## Traffic Impact Study

# Bioscience 5 Aurora, Colo

Comments 7/14/2021:

FIGURE 12

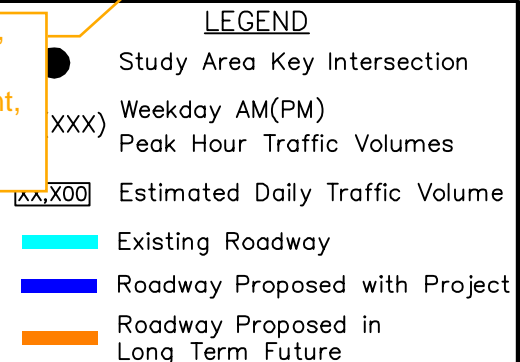
2) See comments on right turn lanes and requirements/waivers thereof on Figure 12. Some locations have heavy right turn volumes on free thru/right movements and warrant right turn lanes. Some others, the volumes are not high and a waiver can be supported by traffic. Care must be taken to balance both the driver expectation and pedestrian crossing factor. Most pedestrians are also drivers and behave differently once they are in the car. In the case of proportionally similar volumes between thru and right turn movements at an uncontrolled approach, thru drivers tend to weave, or aggressively accelerate around right turning vehicles, which results in a less safe environment for pedestrians (and bicyclists, as right turners tend to utilize the bike lanes as pseudo right turn lanes, when they are absent), regardless of the longer crossing distances. Further conversation on the identified movements may be necessary with accompany re-wording of some text in this report to accommodate any changes.

See comments on ability of roundabout to provide operations supportive of waiver of RT lane requirement.

Right turn volume very high, exceeds even through volume. Need a right turn lane here.

These volumes exceed criteria for needing a SB/NB right turn lane. In the case of this intersection, volumes are not heavy, and requirement for right turn aux lane may be waived.

These two intersections may meet warrants for AWSC in 2040. Analysis for that control also provided, and operates acceptably. TWSC is acceptable until AWSC can be confirmed to be warranted in the future.

Heavy AM volume, almost as high as free thru movement, right turn lane warranted here.

K 2) Thank you for waiving the need for several right turn lanes at the project intersections. Based on additional meetings and correspondence with the City and re-evaluation of traffic volumes, it is greatly appreciated that the need for a westbound right turn lane at 22nd Ave/Revere Street and an eastbound right turn lane at 23rd Ave/Revere Street have also been waived.

With the all-way stop control scenario, southbound and westbound right turn lanes have been incorporated at this intersection in the revised traffic study.

Thank you for waiving the need for several right turn lanes at the project intersections. Based on additional meetings and correspondence with the City and re-evaluation of traffic volumes, it is greatly appreciated that the need for a westbound right turn lane at 22nd Ave/Revere Street and an eastbound right turn lane at 23rd Ave/Revere Street have also been waived.
